# DOWNTOWN WEST MIXED-USE PLAN

First Amendment to the Draft EIR

(File Nos.: GP19-009, PDC19-039, and PD19-029)  
SCH #2019080493

Prepared for  
City of San José

**Figure 2-3**  
Proposed Land Use Plan

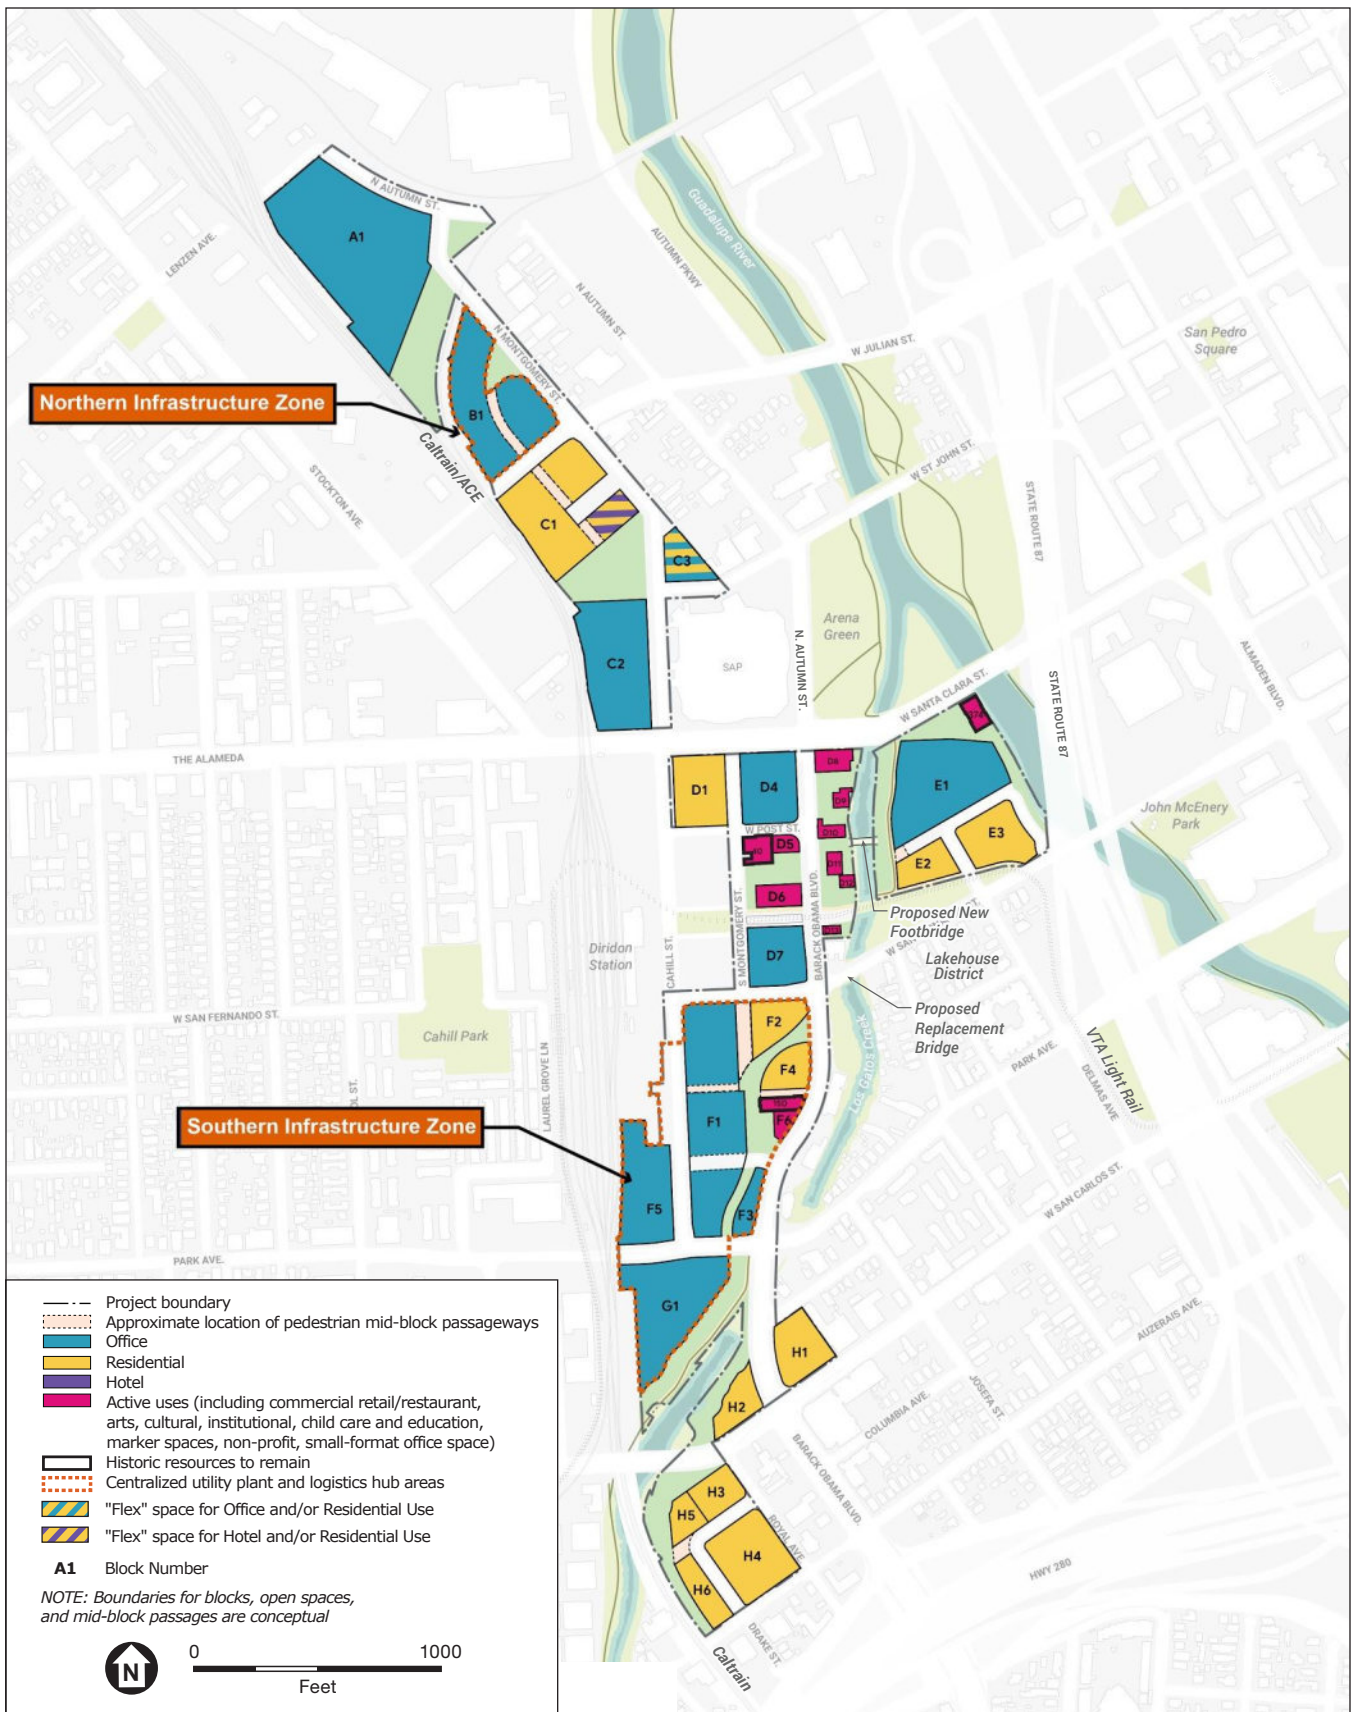
Figure 2-3 of the DEIR includes general land uses within the project site, but includes no elevations of proposed buildings as the City usually requires for such projects. Particulars on massing, heights, building materials, orientation, access, etc. must be imagined by reading a technical appendix and cobbling together what the proposed buildings might look like, building setbacks, their street orientations, general heights, massing, and all other project elements are left to the imagination. We must then determine whether the applicable design guidelines and standards are those that currently exist or are those that are proposed to be modified. A hopeless task.

also to the revised Figure 2.3, Proposed Land Use Plan, and Figure 2.8, Proposed Street Network Changes, in Chapter 4 for a depiction of the revised site plan. Inasmuch as the changes are nearly imperceptible, other figures from the Chapter 2, Project Description, of the Draft EIR will be replaced in the Integrated Final EIR.

**Figure 2-8**  
Proposed Street Network Changes

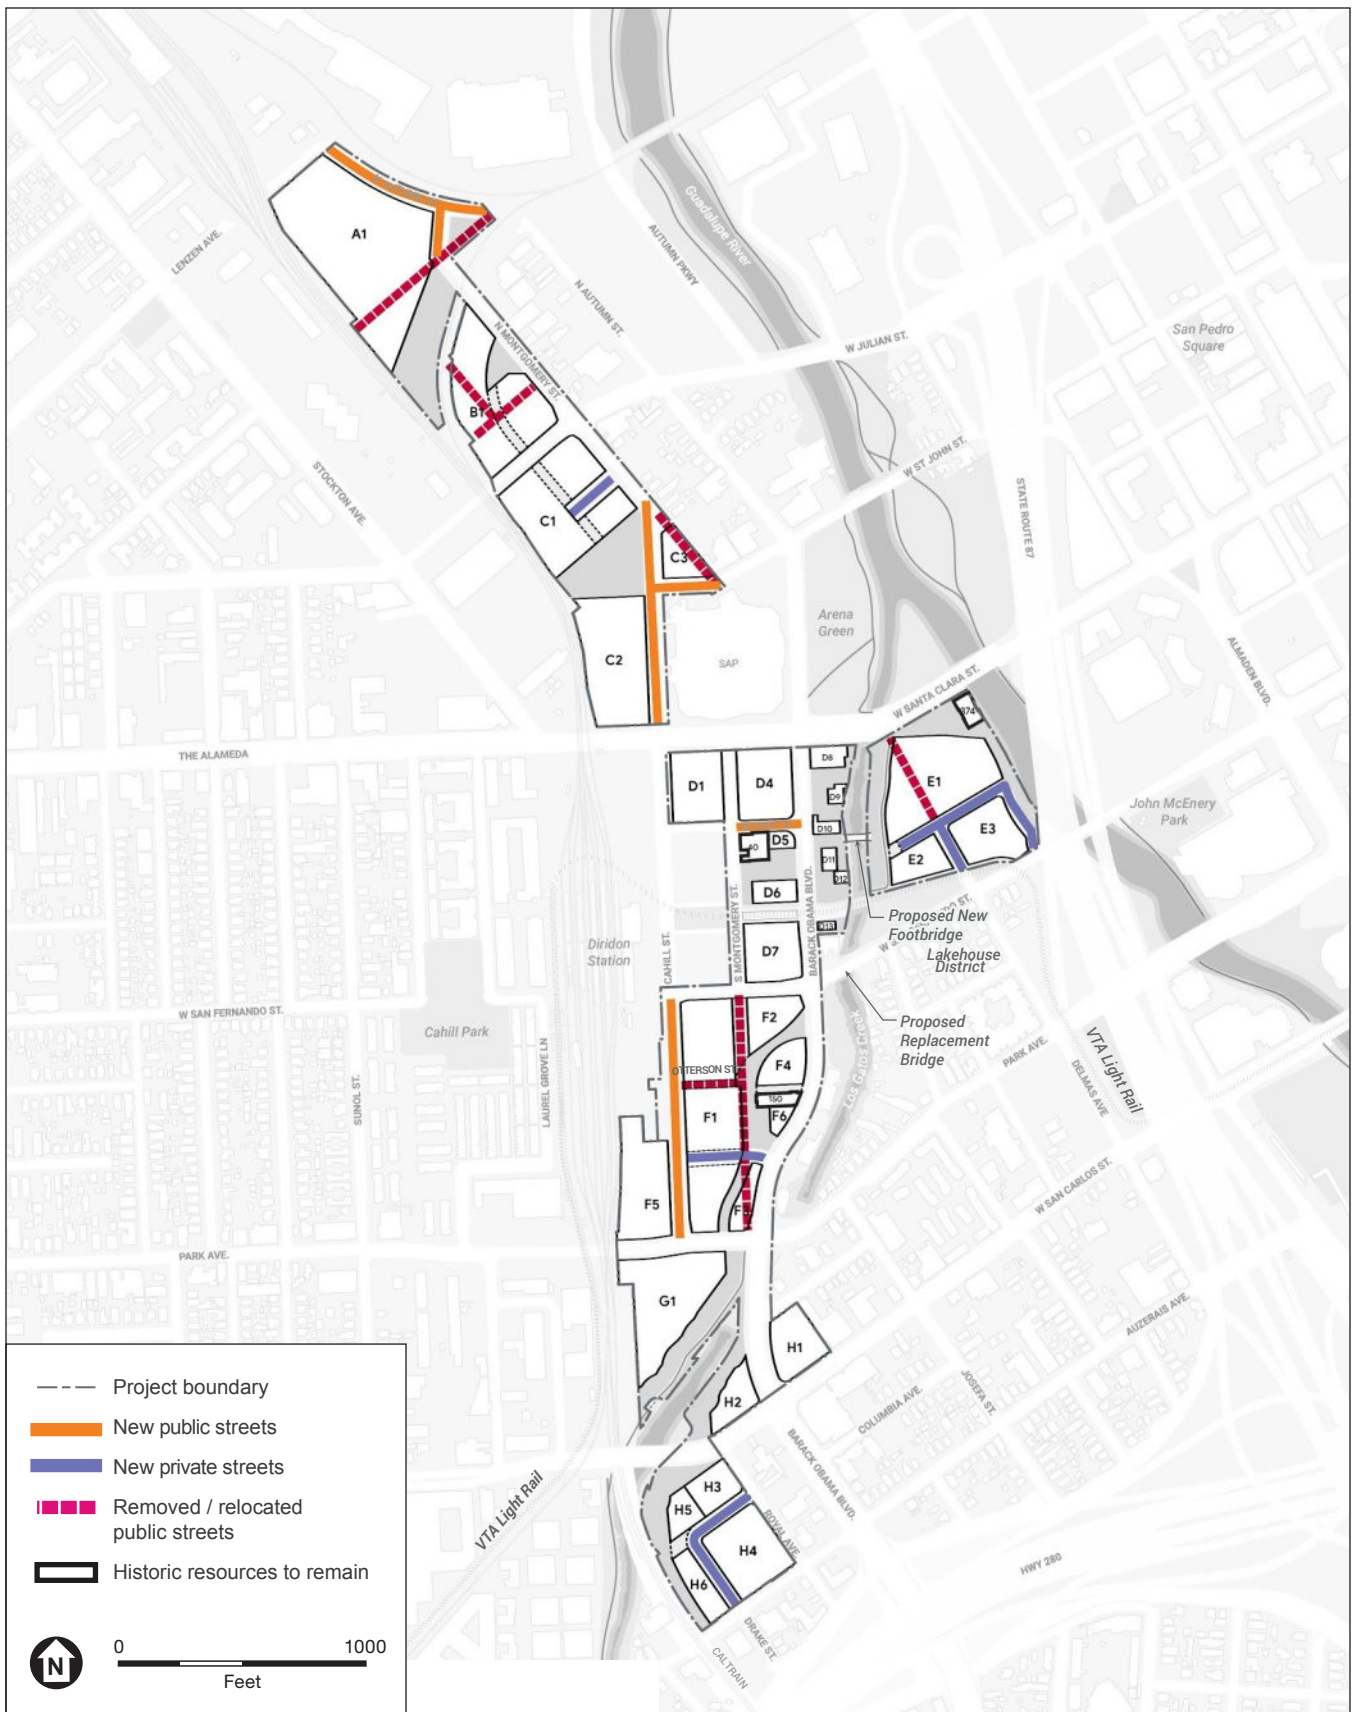
Figure 2-8 shows a new private roadway along the Guadalupe River. Valley Water has easement over and adjacent to the river in this area and the roadway may require a Valley

For either of the options presented, access for large trucks to PG&E's existing San José Station A substation would need to be retained in the City's plans. Figures 2.3 and 2.8 indicate that Otterson Street, which is the only vehicular access route into Station A, will be removed and become a pedestrian path. In order to operate and maintain the substation, PG&E requires access to Station A by trucks hauling trailers that may be 50 feet long and require a large turning radius. Adequate access to Station A for large trucks must be accommodated in any plan to remove Otterson Street.

The private roadways/driveways that would provide internal vehicular access to Blocks E1, E2, and E3 would be accessible from West San Fernando Street and are illustrated in Figure 2-8, *Proposed Street Network Changes*, on Draft EIR page 2-39 (as revised herein in this First Amendment). As stated on Draft EIR page 3.13-47, any roadway extensions and new streets would need to comply, subject to allowances pursuant to Municipal Code Titles 13 and 19, with the City’s Complete Streets Design Standards and Guidelines,<sup>110</sup> which include design specifications that consider emergency vehicle access requirements. Design requirements could include mountable concrete buffers, mountable curbs, and corner or sidewalk bulbs to accommodate turning of emergency vehicles. All new street segments would be designed in

**Figure 3.10-2**  
Noise Monitoring Locations

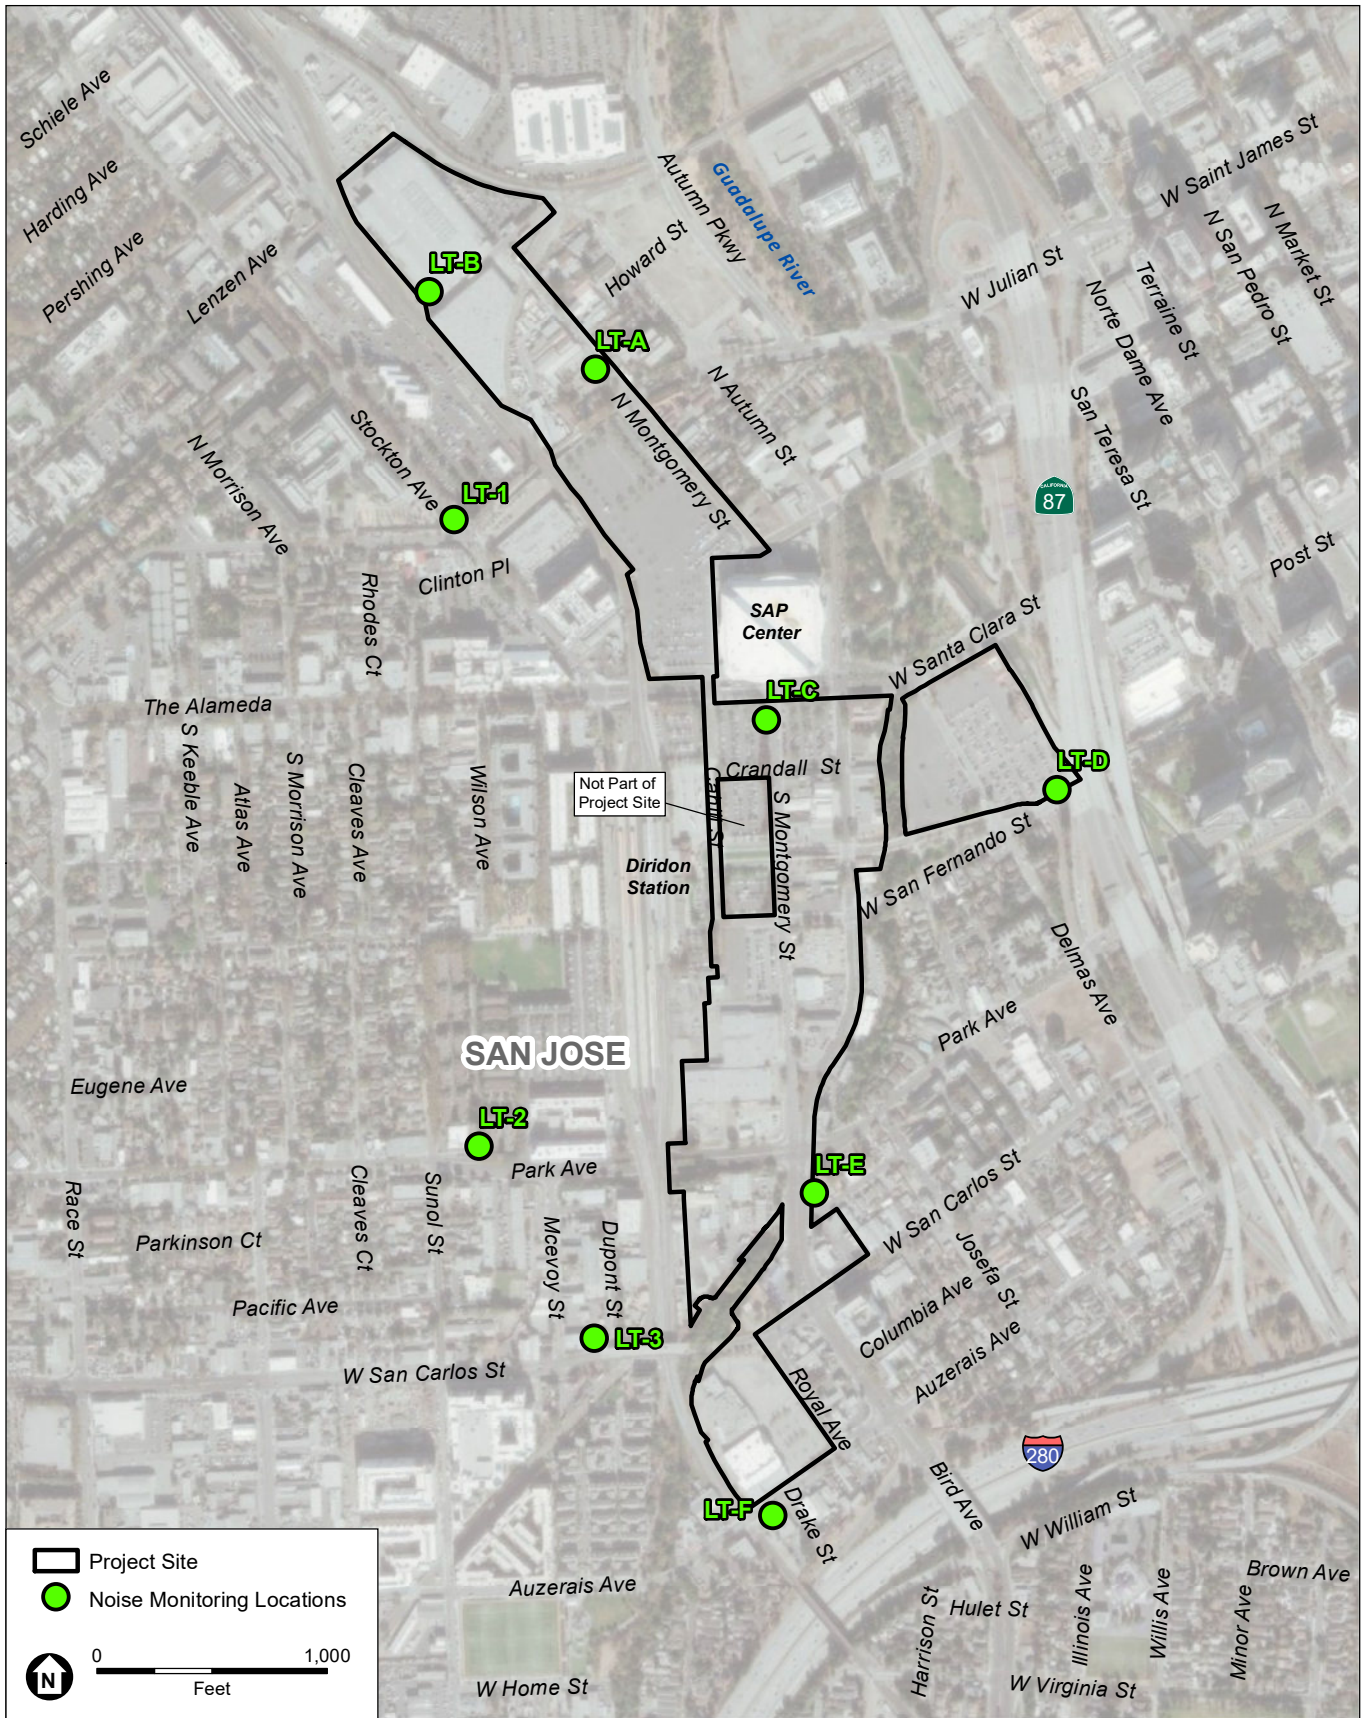
**Section 3.10.1, Pg. 3.10-8 and Fig. 3.10-2** – Noise levels at monitoring station LT-2 were monitored in February 2018, and the data were used as baseline noise environment for the site. The narrative states that no substantial development occurred in the area between the time of monitoring and the NOP date. However, during that time construction of a residential building occurred on the northeast corner of Park Ave. and Laurel Grove Lane, directly across Park Ave. from the LT-2 monitoring site. It is questionable whether the 2018 data represent accurate baseline data.

The commenter is correct that a new residential development at the northeast corner of Park Avenue and Laurel Grove Lane was under construction into the year 2020. However, monitoring station LT-2 was incorrectly mapped in Figure 3.10-2, Noise Monitoring Stations. As shown in the Integrated Final EIR for Downtown Strategy 2040 (Figure 3.12-1, Noise Measurement Locations, page 222), this monitoring location was actually approximately 200 feet west of Laurel Grove Lane, on the north side of Park Avenue and west of where the street begins to descend beneath the Caltrain rail bridge; the correct location was about 150 feet east of Sunol Street. Therefore, construction noise from work on the Laurel Grove Apartments and the Park Avenue Senior, on the parcel at Park Avenue and Laurel Grove Lane, would have been attenuated by distance and partially shielded by the existing multi-family residential buildings on the north side of Park Avenue at Georgetown Place, as well as by the dense landscaping along that side of Park Avenue. While noise levels at monitoring location LT-2 could have, at times, been louder than typical noise levels due to operation of construction equipment, it is not expected that construction noise would have substantially altered the baseline noise level at this location. To correct the location, Draft EIR Figure 3.10-2, page 3.10-7, is revised (see Chapter 4, *Revisions to the Draft EIR*, of this First Amendment), and Table 3.10-1, Existing Noise Environments in the Project Vicinity, page 3.10-9, is also revised, as follows (new text is double-underlined; deleted text is shown in ~~strikethrough~~):

Page 3.10-7 Figure 3.10-2, *Noise Monitoring Locations*, has been revised to reflect the correct location of measurement location LT-2 and is provided following this section.
